Project	IEEE 802.16 Broadband Wireless Access Working Group < http://ieee802.org/16 >
Title	Formats change for Figures 477 and 478
Date Submitted	2006-09-25
Source(s)	Peretz Feder - Lucent Technologies [mailto: pfeder@lucent.com]
Re:	
Abstract	This contribution proposes changes to Figures 477 and 478
Purpose	Adoption
Notice	This document has been prepared to assist IEEE 802.16. It is offered as a basis for discussion and is not binding on the contributing individual(s) or organization(s). The material in this document is subject to change in form and content after further study. The contributor(s) reserve(s) the right to add, amend or withdraw material contained herein.
Release	The contributor grants a free, irrevocable license to the IEEE to incorporate material contained in this contribution, and any modifications thereof, in the creation of an IEEE Standards publication; to copyright in the IEEE's name any IEEE Standards publication even though it may include portions of this contribution; and at the IEEE's sole discretion to permit others to reproduce in whole or in part the resulting IEEE Standards publication. The contributor also acknowledges and accepts that this contributi

Figure 478 – Context transfer primitives initiated by a target BS

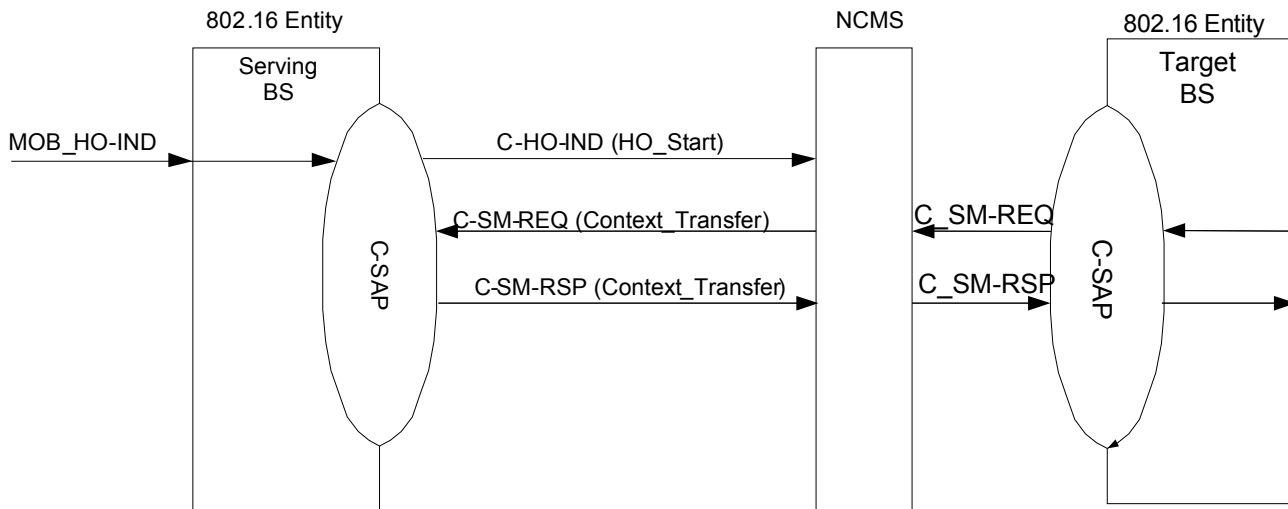
Figures 477 and 478 are hard to comprehend when combining call flows of serving and target BS within a single entity.

Split the serving and target BS and show call flow exchange through the NCMS

Split Serving BS and Target BS call flows per below:
